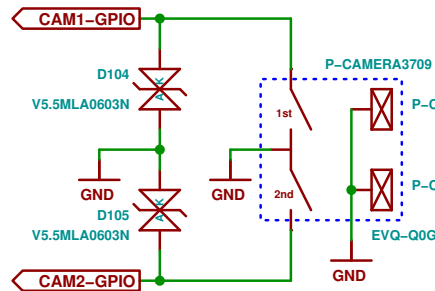
place in scan matrix? would need 3-4 wires to UPPER board instead of 2-
 No. VOL+ or VOL- can either be connected to GPIOs
 or drive two FETs that sit in the keyboard matrix
 in any case it is sufficient to connect GPIO-VOL+ and VOL- to two pins on the B2B connector

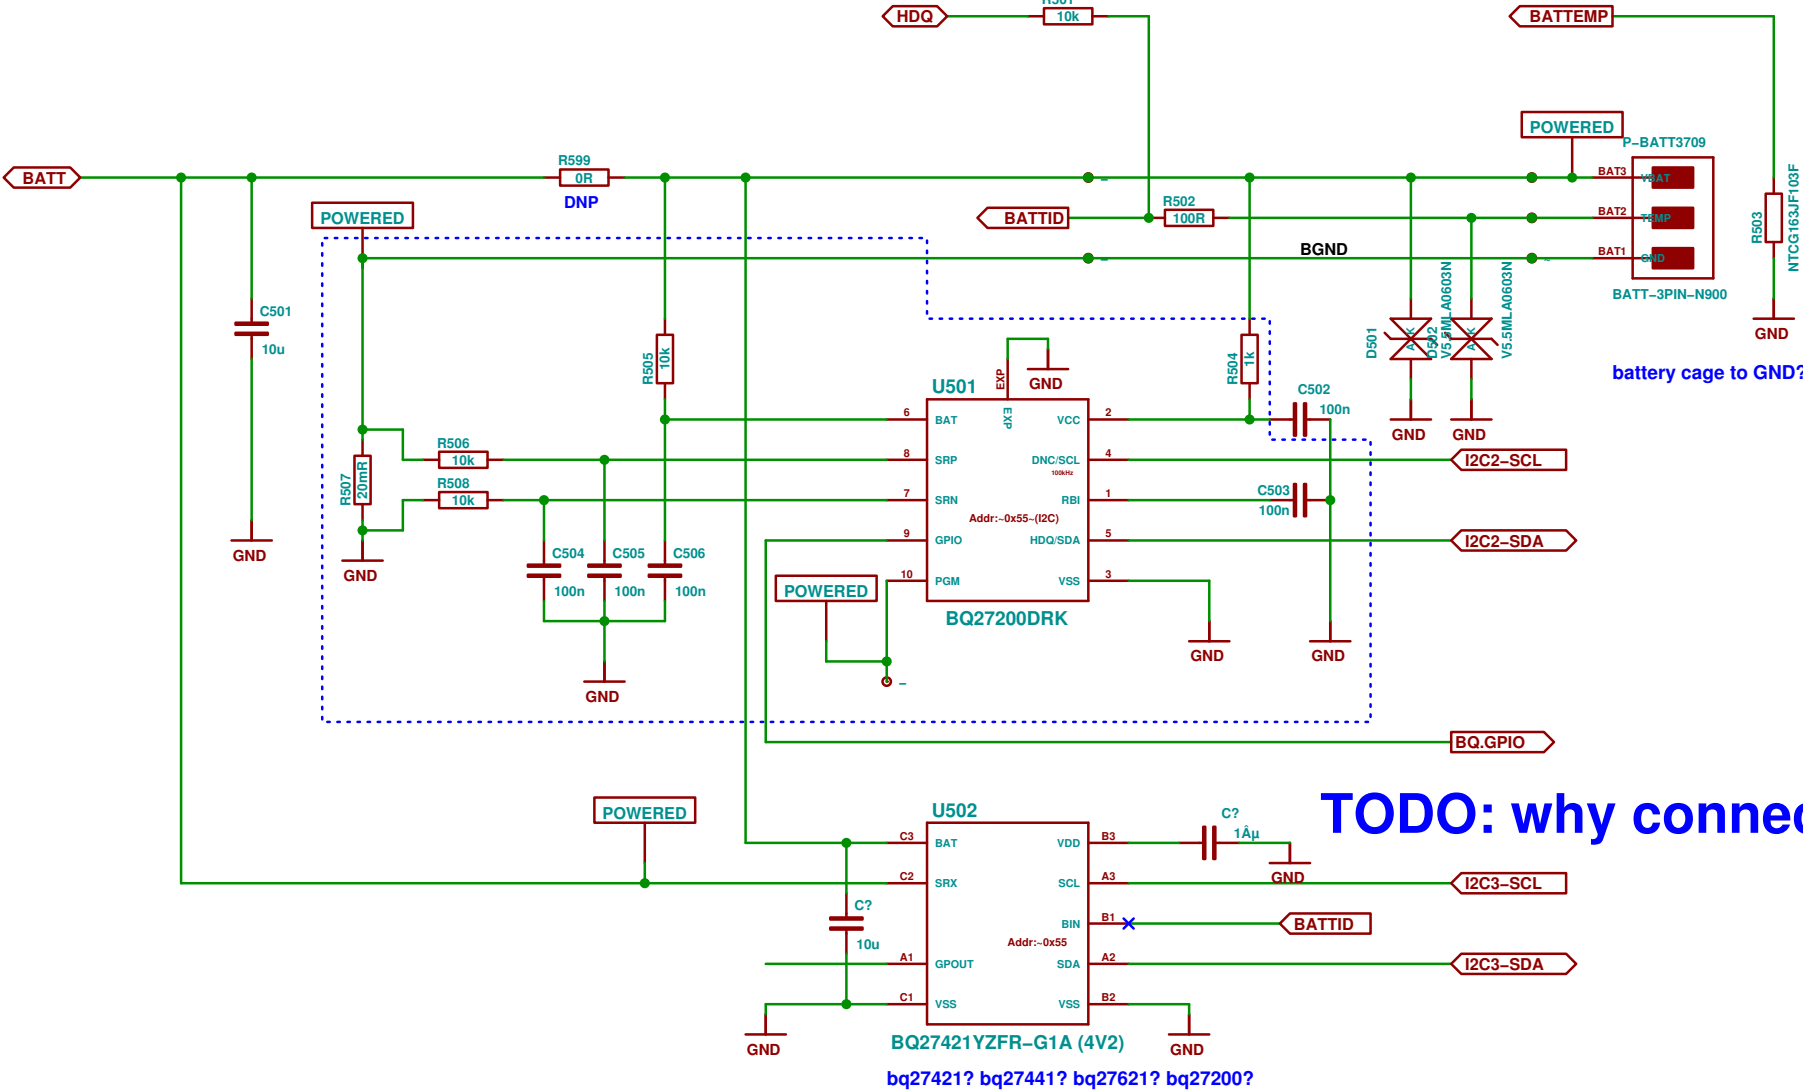
TODO: why connect

TODO: can U501 and U502 coexist ?

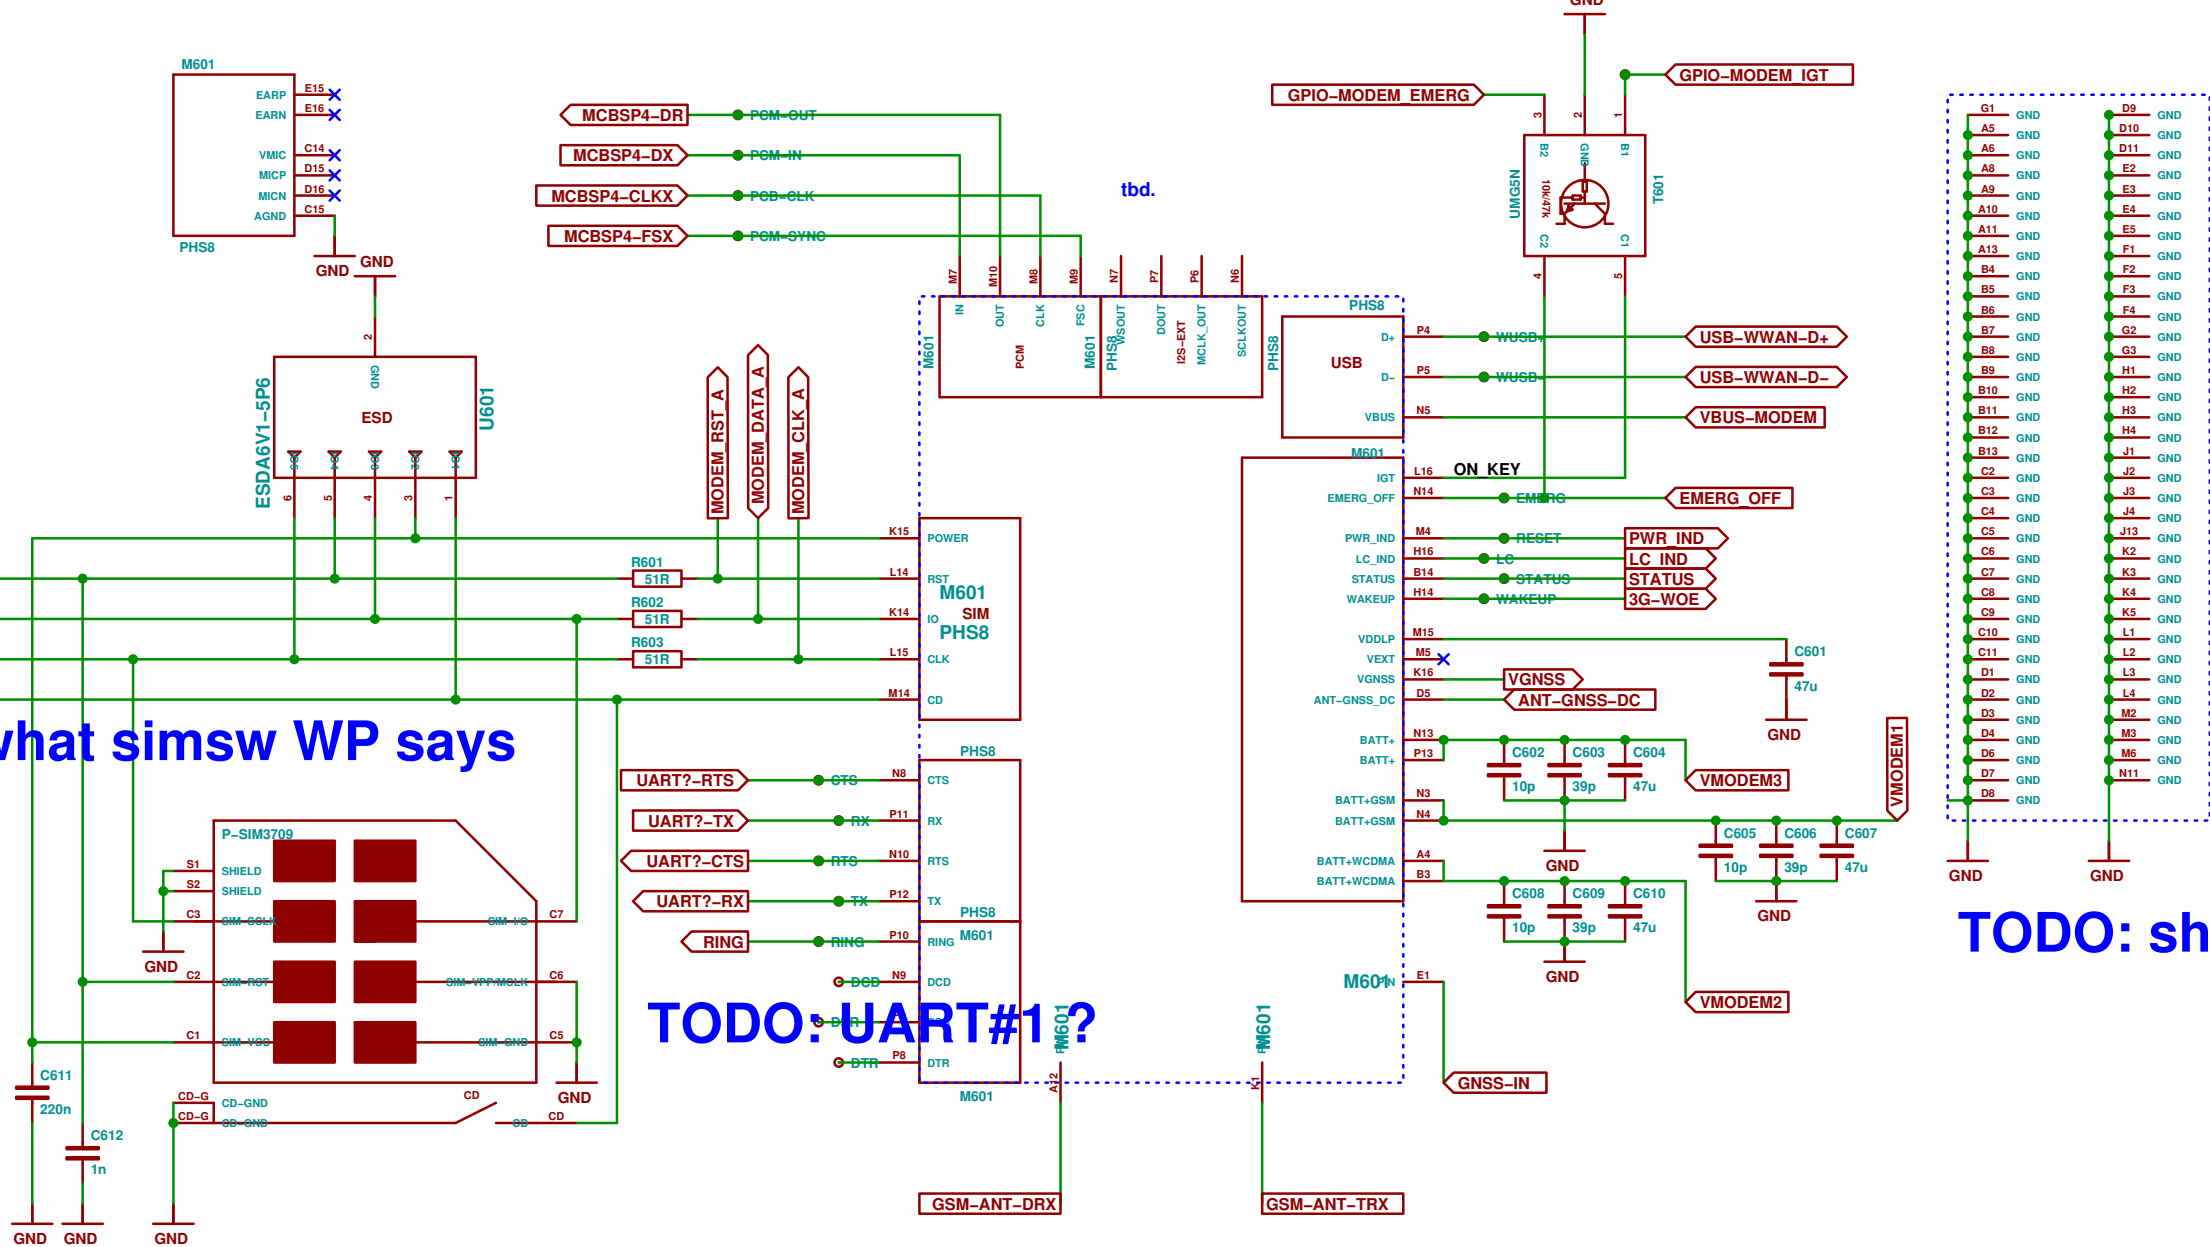
TODO: BQ27421YZFR-G1A

bq27421? bq27441? bq27621? bq27200?

TODO: do what simsw WP says

TODO: UART#1?

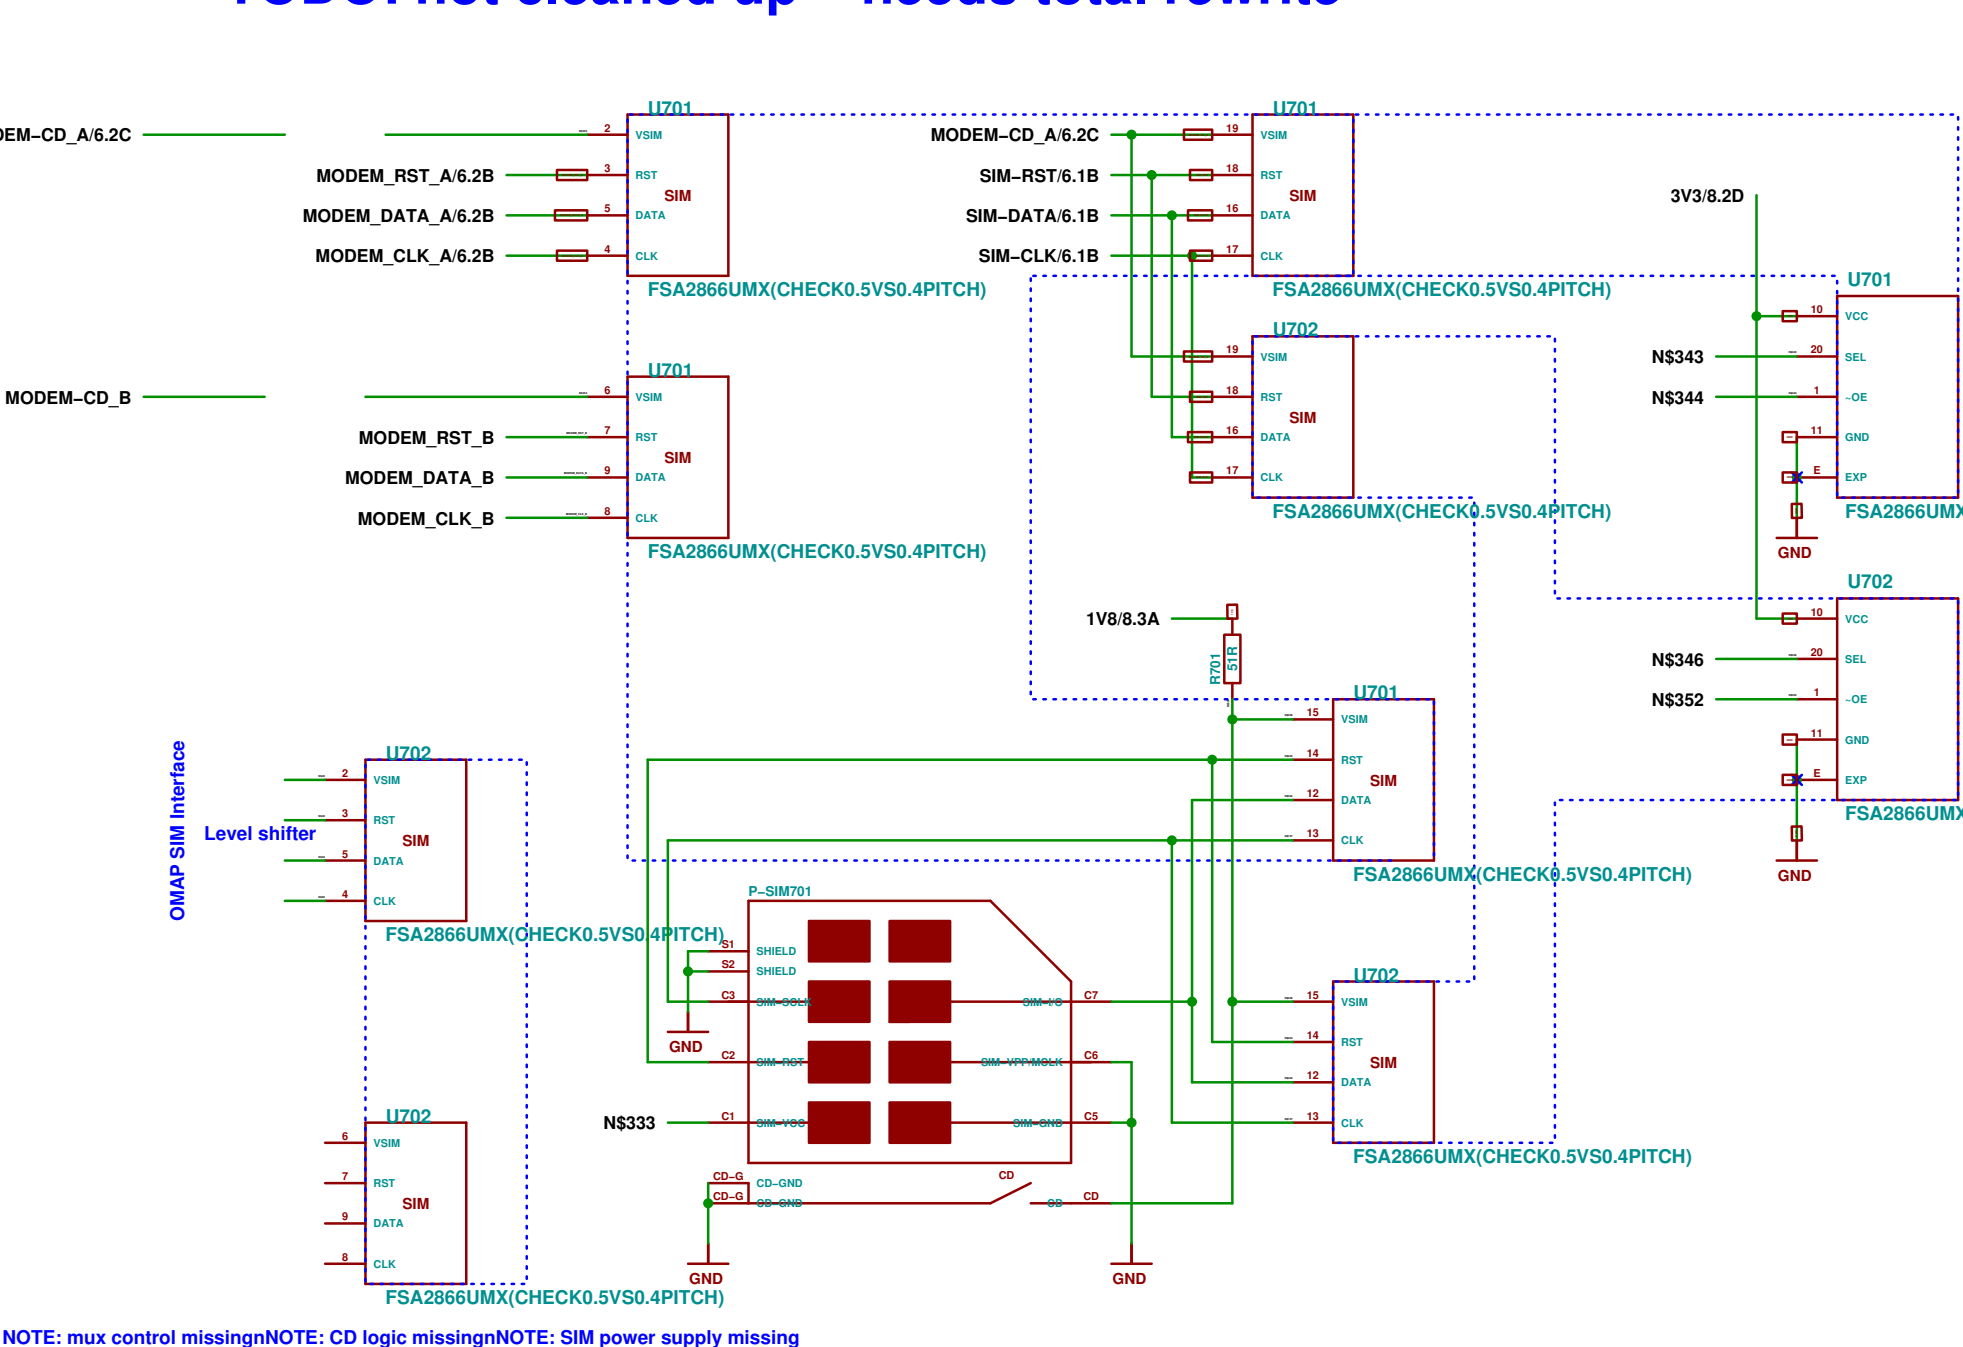
Can we connect UART in parallel to Bluetooth UART (i.e. if BT is disabled we can unbrick the Modem?)

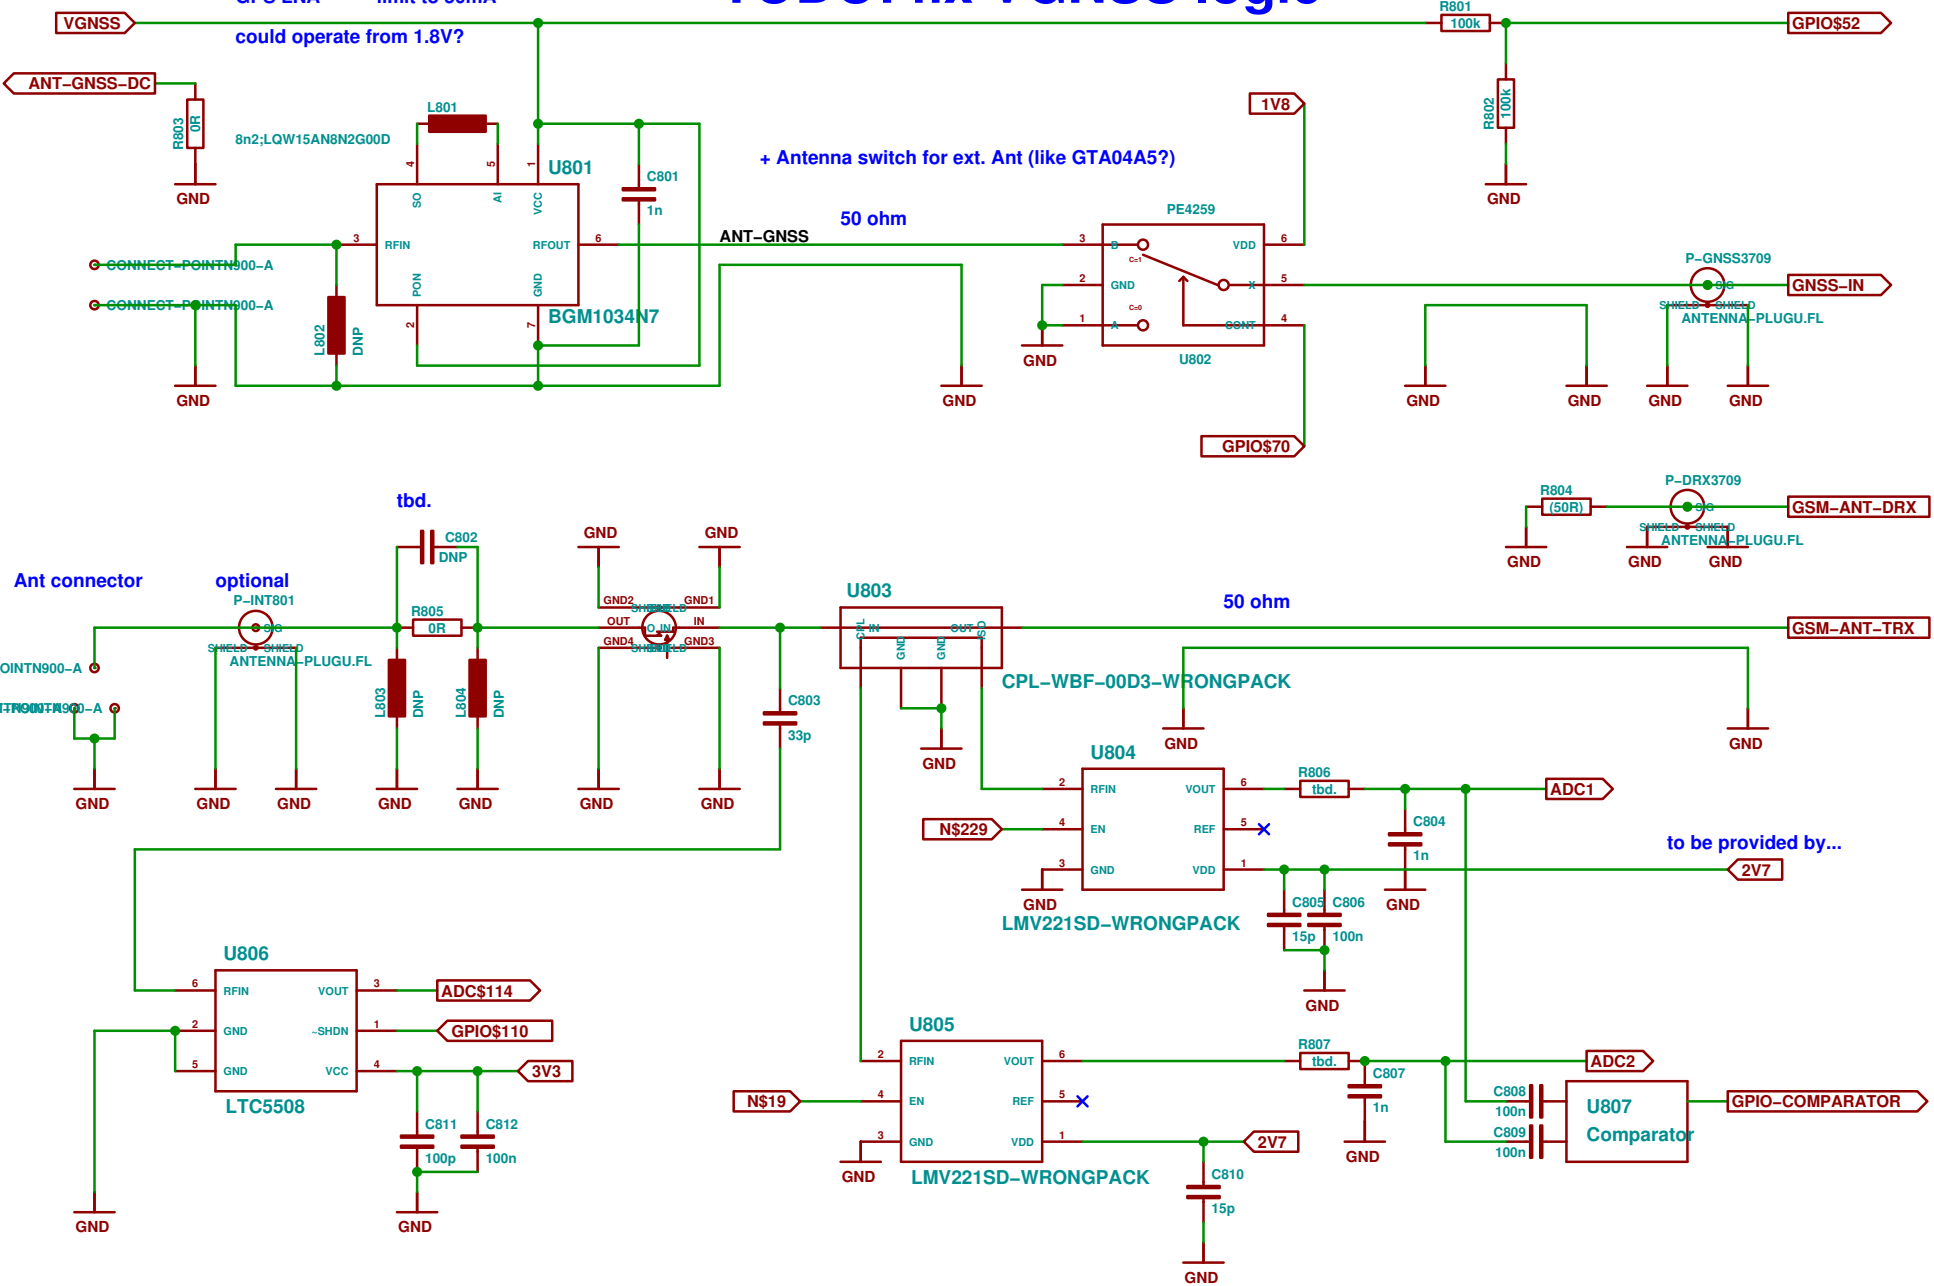
NOTE: mux control missing
 NOTE: CD logic missing
 NOTE: SIM power supply missing

TODO: name all the *\$*

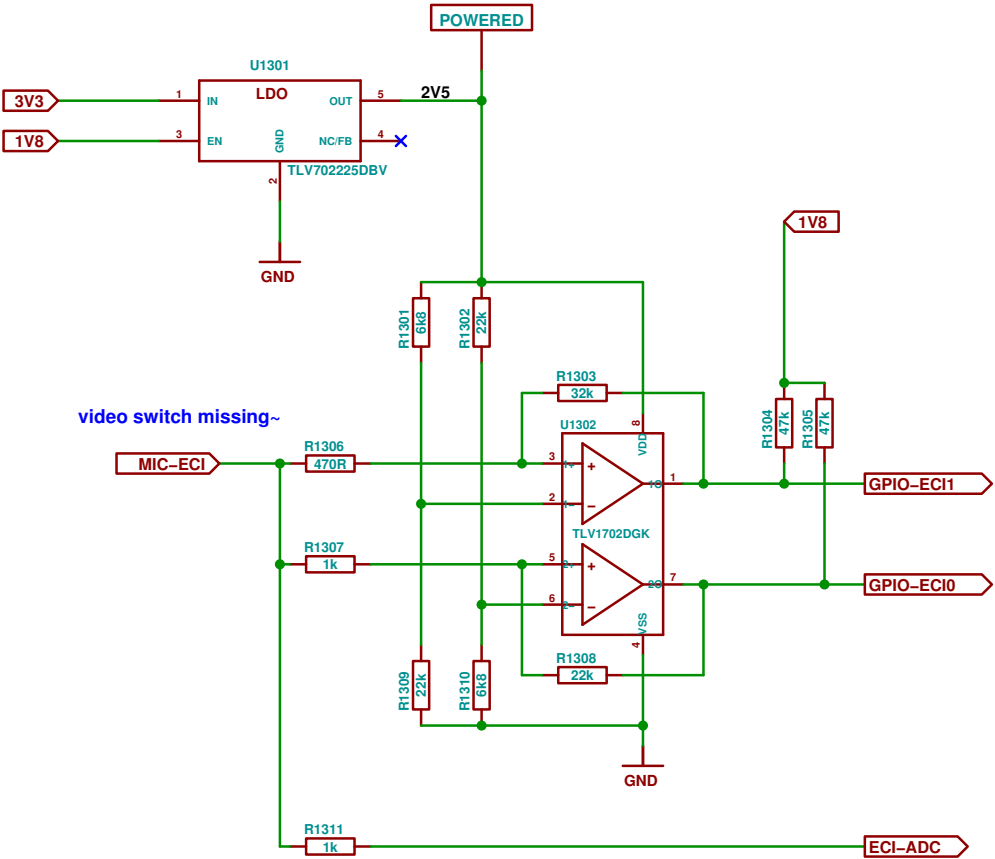
problem: analog mic is on upper board~
 alternative: place on upper board (to be evaluated)

TODO: draw comparator right

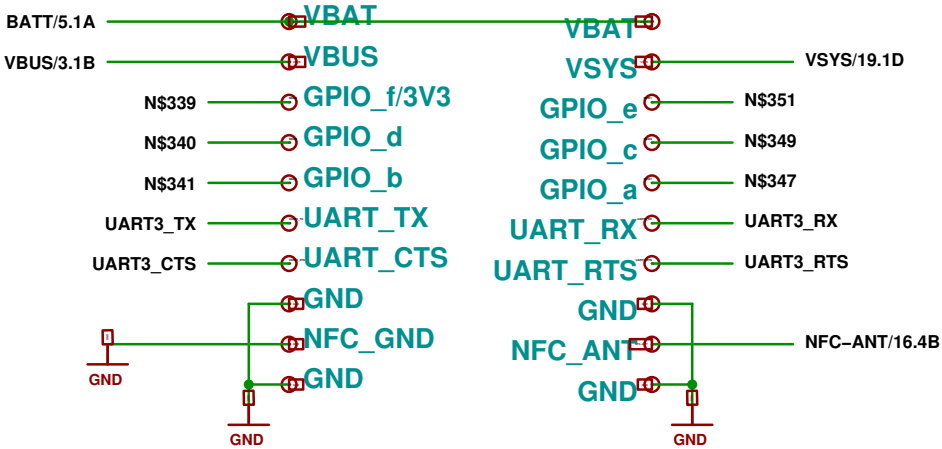
TODO: align with HB WP

Missing 10 level shifter chip (or do we really have the space for 10x discrete T+R+D ca. 3x3mm each?)

Missing 6x 2R for alternate function select (do we have the space for ca. 2.5 x 5mm?)

TODO: align with HB WP
